### **Appendix 1-2    Initial Study/Mitigated Negative Declaration Response to Comments**

May 2020 | Response to Comments on Mitigated Negative Declaration  
SCH # 2020029070

# DEL MAR HEIGHTS SCHOOL REBUILD PROJECT

**Figure 7 Comparison of Area Available for Community Recreation**

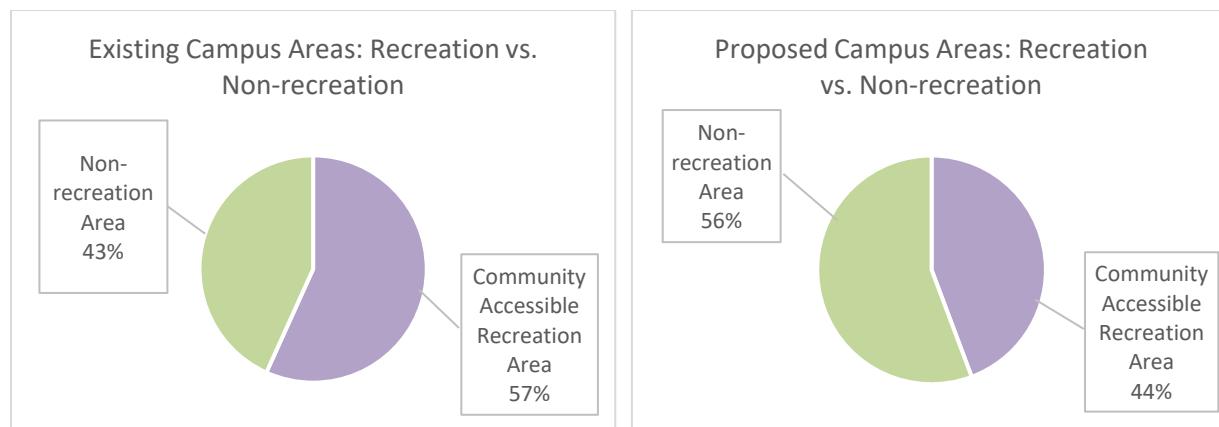
- J-29 See responses to J-28.
- J-30-31 The District asserts that the loss of recreational space has been overstated as demonstrated through views of Figure 3, *Open/Community Accessible Areas*, Figure 8, *Comparison of Community Accessible Areas by Type*. Although the amount of useable recreation space would decrease under the proposed plan, the project also includes

The existing campus is approximately 11.3 acres (492,064 square feet) in area. On the existing campus, 279,292 sf (57 percent of the campus) is accessible to the community for recreational use. The proposed campus will have 217,952 sf (44% of the campus) available to the community for recreation. This is a decrease of 61,340 sf, or an approximately 22% decrease. See Figure 7.

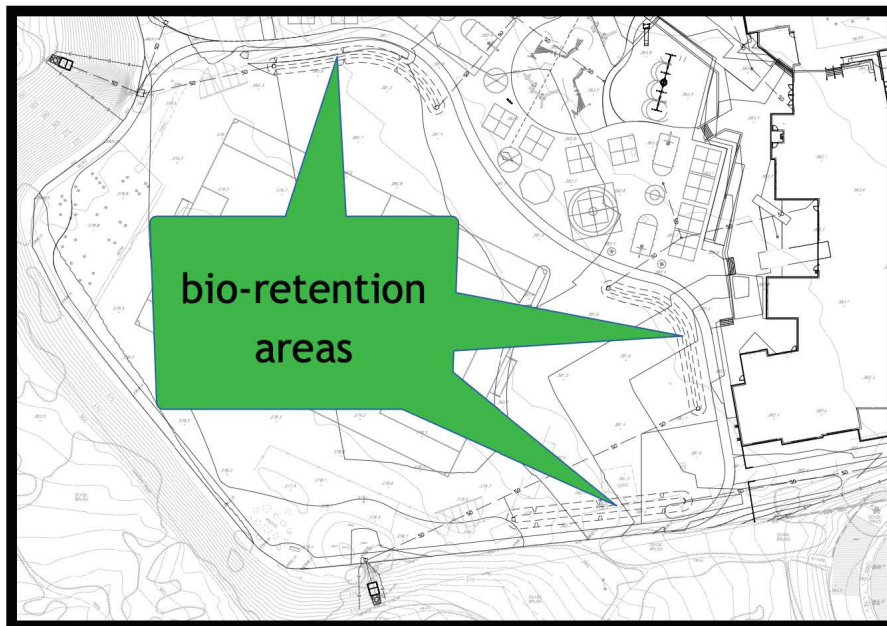
The 160,000 square foot field has been one of two Del Mar Heights' community parks for over 50 years starting with the two baseball fields installed in 1970 with citizen funds.<sup>19</sup> The 50 percent reduction of the field - from 160,000 sf to 78,000 sf - is taking away a vital recreation area for the Del Mar/Carmel Valley community.

- Also refer to Student Capacity, which is contained in Master Response 2.1.1, *Project Description*.
- J-41 The District acknowledges the proposed project modifies the green space area to advance the District's education and safety goals. The District asserts that the loss of recreational space has been overstated as demonstrated through views of Figure 3, *Open/Community Accessible Areas*, and Figure 8, *Comparison of Community Accessible Areas by Type*. Although the amount of useable recreation space would decrease under the proposed plan, the project also includes enhanced recreational facilities for use by students and community members. Refer to Master Response 2.1.5, *Recreation/Green Space* for additional details.

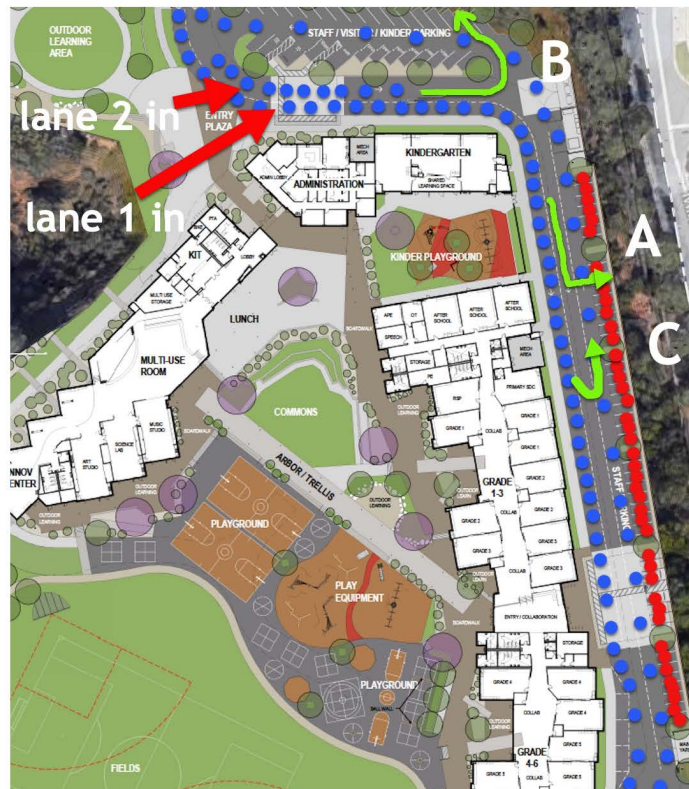
There is no traffic study or even analysis of the critical three lane onsite queue - not for normal operation or for site evacuation and emergencies. A fair analysis shows the bulk of the “problems” identified anecdotally in the MND have not been eliminated, but instead moved onsite into a longer, narrower, more captive channel - and made worse by new opportunities.

The three lane onsite queue combines emergency vehicle access, bi-directional traffic, drop-off, pick-up, merger of two lanes into one at the south turnaround, and forty-five 90° angle parking spots into a width that is seven feet narrower than Boquita Drive. Once you get in, if you follow the rules, you are stuck until you go all the way to the south roundabout and make your way back. Every one of the forty-five staff parking spots pulls out into the single outbound lane of the queue. If you want to park in one of the staff spots, you must wait until you get to the turnaround and head back north - assuming you follow the rules rather than just cut across traffic and grab an open spot.

Location of 30 foot high “Innovation Center” shrinks defensible fire space to less than 20 feet on the canyon rim

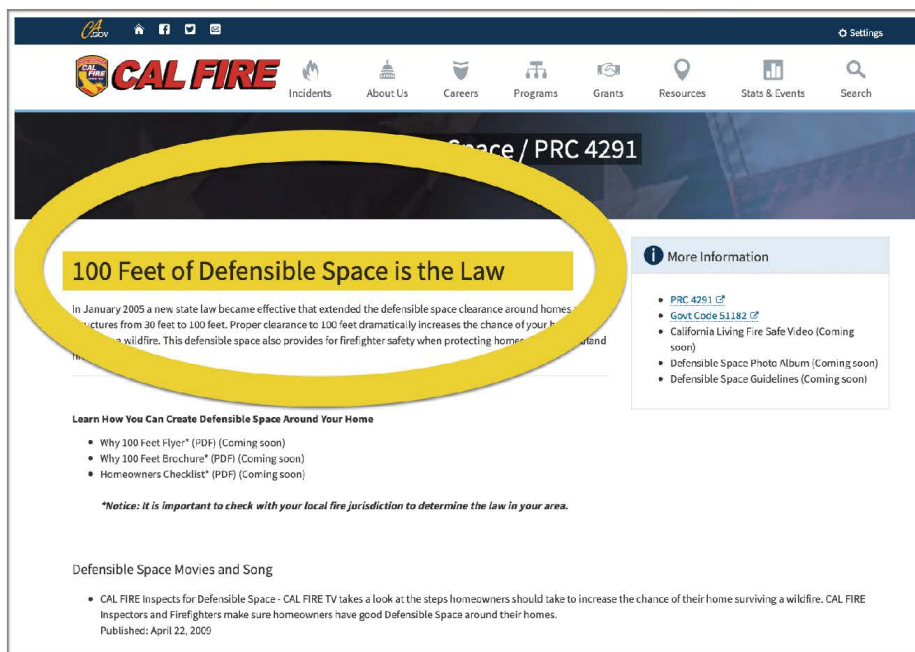
A core concept in reducing wildfire risk is the notion of “defensible space.” “Defensible Space is the area around a structure where combustible vegetation that can spread fire has been cleared, reduced or replaced. This space acts as a barrier between a structure and an advancing fire.”<sup>45</sup>

- JJ-146 The Board of Education will consider all comments in its deliberations concerning the project.
- J-147 See responses to J-98 and J-120.
- J-148-154 The existing fire access lane is inadequate as the width of the lane is only 10 feet between the edge of the slope and the building. The minimum width is 20 feet per the 2019 California Fire Code. The proposed fire lane is 20 feet in width throughout its length and it eliminates the existing restricted access point (see Figure 7, *Fire Access Lane*). The fire lane includes hammerhead turnarounds and the hose length distances are in compliance with the 2019 California Fire Code. Further, the plan has been reviewed and pre-approved by the City of San Diego Fire Marshall.
